<b>To:</b>	QLDC Resource Consent Team
<b>From:</b>	Dominic Harrison
<b>Date:</b>	Wednesday, 17 December 2025
<b>Subject:</b>	<b>Ayrburn Screen Hub - s53 Fast-track Approvals Act 2024 Comment Technical Memorandum – Parks and Reserves</b>

1. This memo provides comment from a Parks and Reserves perspective on the Ayrburn Screen Hub substantive application under the Fast-track Approvals Act 2024.
2. It was prepared by Dominic Harrison.

*Figure 2: Ayrburn Structure Plan. Tree Protection Area relevant to the current proposal marked by the red arrow. Source: QLDC Proposed District Plan Chapter 27.*

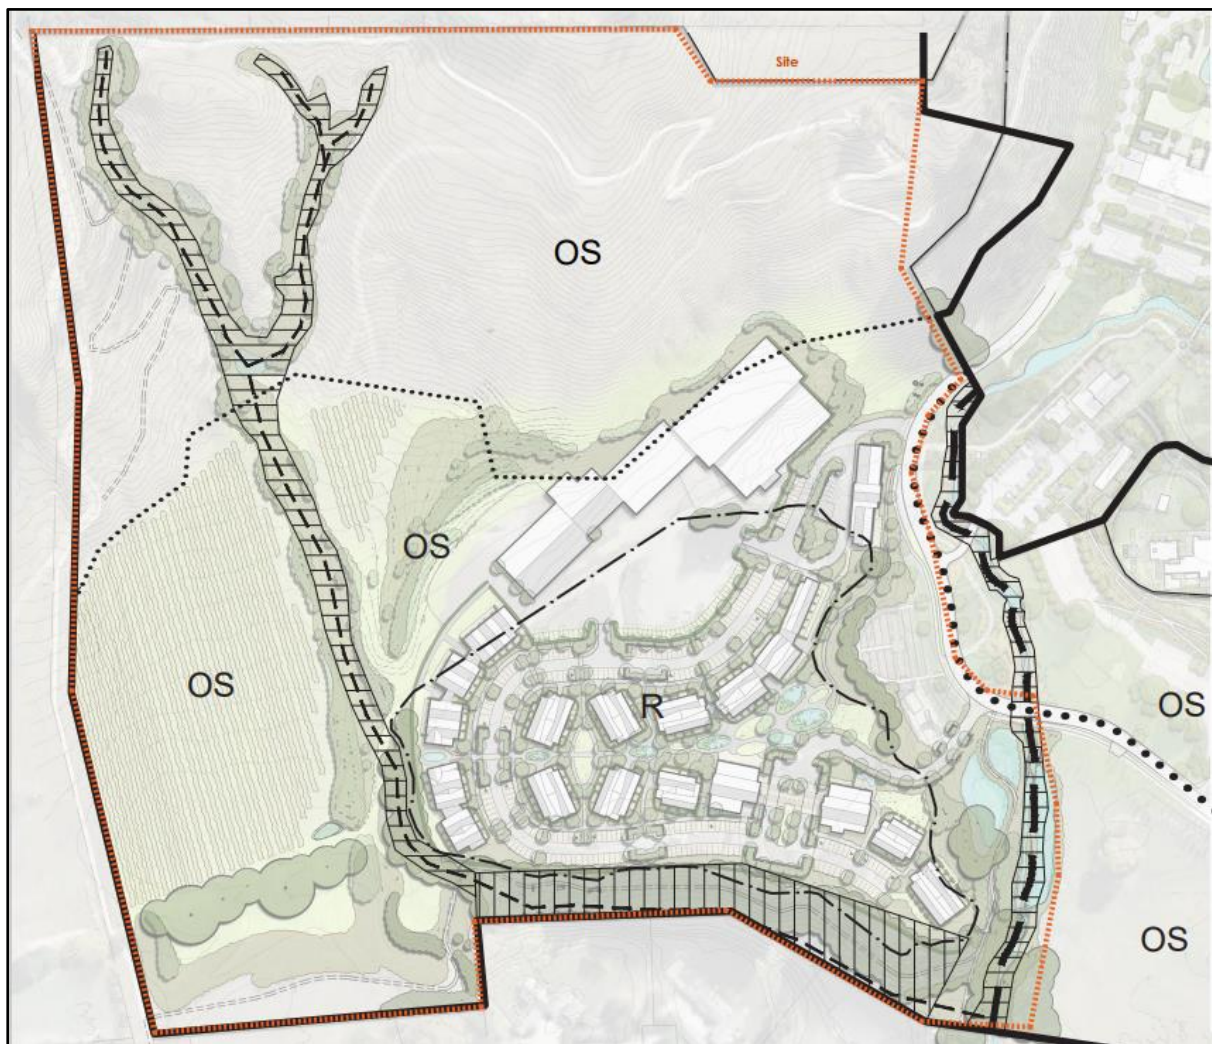
27. The conifers are large Douglas fir, which are classified in the Otago Regional Council Pest Management Plan<sup>1</sup> as an invasive wilding exotic species. Rule 34.4.2 of the QLDC Proposed District Plan also prohibits the planting of Douglas fir.
28. The approved subdivision consent for the site directs the conifers (shown in Figure 5) be retained in perpetuity through a consent notice (condition 15c of RM240982) reflecting exactly the wording in rule 27.7.32.2.c.aa. This includes the ability for the consent holder to replace these trees by first planting replacement Trees which will achieve the same or similar visual screening effect.

29. Parks and Reserves understand condition 15c was put in place to mitigate the visual impacts of the Ayrburn development when viewed from adjoining properties.

30. To contribute to positive environmental outcomes, the applicant is encouraged, as part of implementing RM240982, to provide sufficient replacement planting on the landscape plan as detailed by PDP rule 27.7.32.2.c.aa and Condition 15(c) RM240982. As these trees provide a screening currently to this development, implementing replacement planting sooner rather than later would allow the conifer hedge to be removed in the future at such a time the replacement planting reaches a height of 4m with no requirement for a variation to any consent.

Figure 4: Trail plan showing Trail A (purple), Trail B (Red), and Trail C (Blue). Source: Application, Appendix 7, p.24.

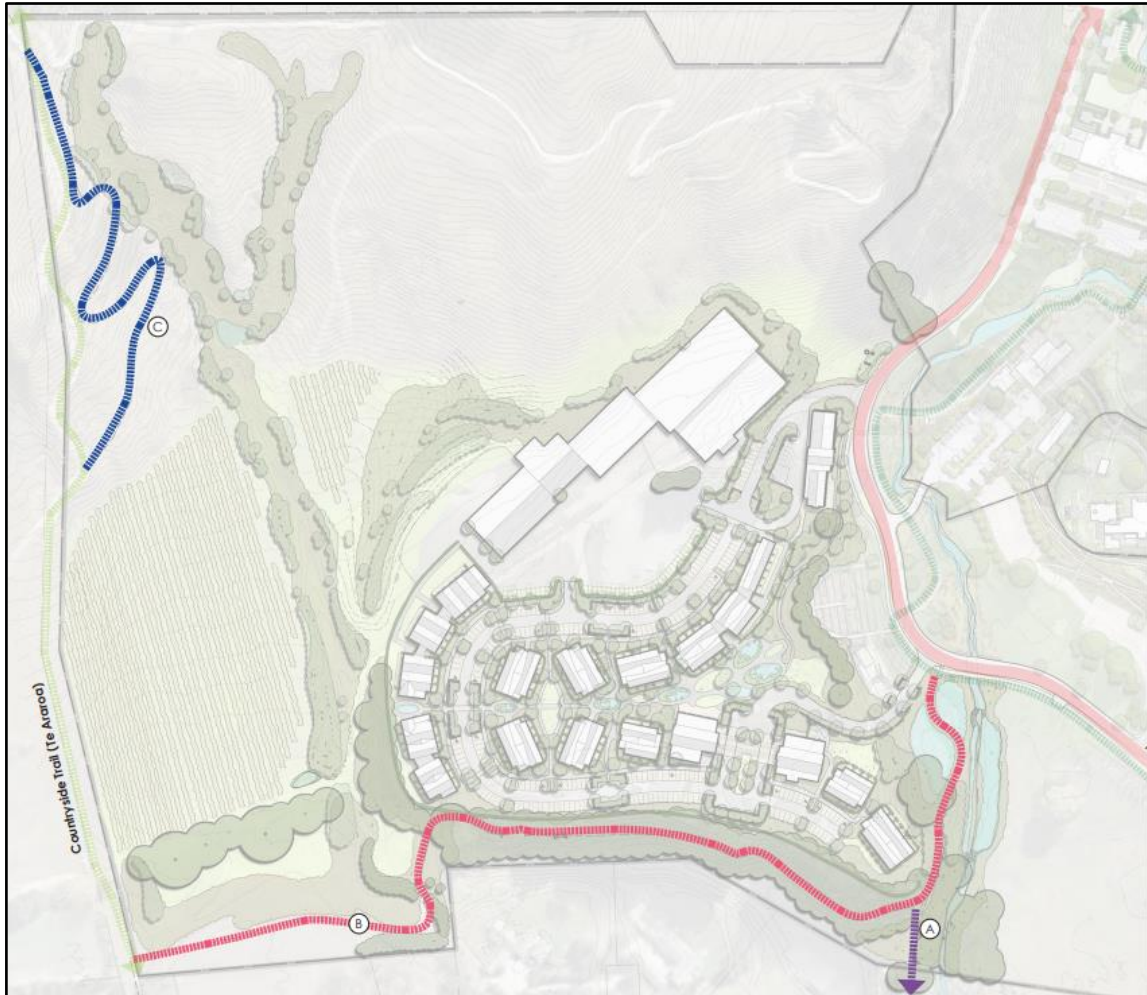
19. Trail A is a relatively short connection but as no land is to be vested, it will provide for future connection opportunities outside of the subject site. This connection will ensure potential future access to Lake Hayes to the south is available along the margins of Mill Creek. This will contribute to a better-connected trail network that considers the wider catchment and will be a positive outcome for the wider community.

20. Trail B will provide a logical connection from Mill Creek esplanade reserve to the existing trail network to the west (Countryside Trail). This will increase public access and connectivity to the subject site and Mill Creek. This is considered a logical alignment that will benefit the wider community and contribute to the Blue Green network positively.

21. Trail C will provide a realignment to the existing Countryside Trail. This current section of the Countryside Trail is steep and presents some complexities for some trail users. The realignment will provide a gentler grade that is easier for all users to navigate, increasing the accessibility of the trail. This is considered to be an overall positive outcome that will improve the user experience of the Countryside Trail.

22. To ensure the existing section of the trail that is to be replaced/realigned does not generate adverse effects, the applicant should be responsible for decommissioning and remediating/recontouring to match the surrounding topography. A condition of consent has been recommended at the end of this memo to ensure this is addressed.

- XII.** Access and maintenance works easements must be secured over the pedestrian and cycle trails identified as Trail, A, B, and C. These shall be Right of Way easements in gross in favour of QLDC. The easement agreements must be approved by the Parks and Open Spaces Planning Manager prior to registration.

- XIII.** The consent holder must remediate/decommission the existing section of the Countryside Trail that is being realigned within 3 months of the new trail being completed. This will include recontouring to match the surrounding landform.
